Application reference: PAN-000849

Applicant: Radnor Hills Mineral Water Company Ltd

Facility: Radnor Hills, Heartsease, Knighton, Powys, LD7 1LU

We are responding to your Schedule 5 notice dated 31st January 2017 on behalf of Radnor Hills Mineral Water Company Ltd.

Figure 2 - Proposed discharge point (excerpt from RAD02-4-100-1-001).

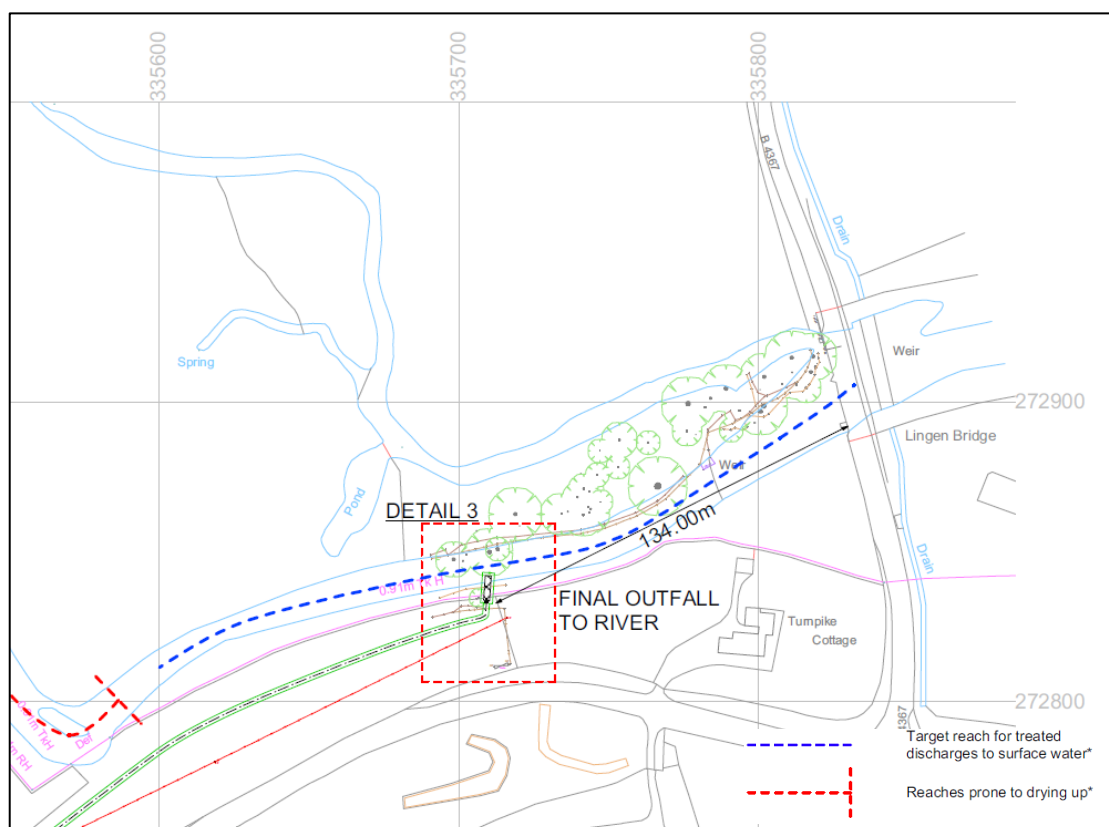
The permeate from the MBR will be piped to the nearest point downstream on the River Teme where flow is continuous year-round, at a point 134 metres upstream of Lingen Bridge. This is a distance of c.1.2 kilometres from the manufacturing plant, and will require pumping.

The location along the river at which there is continuous flow has been identified using information provided by the Environment Agency (P. Giles, 3rd March 2016), and is corroborated by the anecdotal experience of Radnor Hills and being east (downgradient) of where springs rise to the north of the river. The proposed discharge point is well within this reach of continuous flow.

Due to land ownership boundaries, this point is the furthest downstream that can be accessed from the south bank of the river. A river crossing was investigated as an option to take the outfall closer to the bridge (as flow does increase a little further downstream), however due to the very different heights of the north and south bank, the presence of overhanging branches and tree roots, and the susceptibility of the north bank to flooding, this was deemed to be unfeasible. As the proposed discharge point on the south bank is well within the reach of continuous flow, a river crossing to the south bank has also been deemed unnecessary.

Figure 2 shows an excerpt from RAD02-4-100-1-001 prepared by Wildfowl & Wetlands Trust (Consulting) Limited (WWTC), and shows the proposed location of the outfall. As can be seen, it is around 100m downstream of the location where the river flow is continuous.
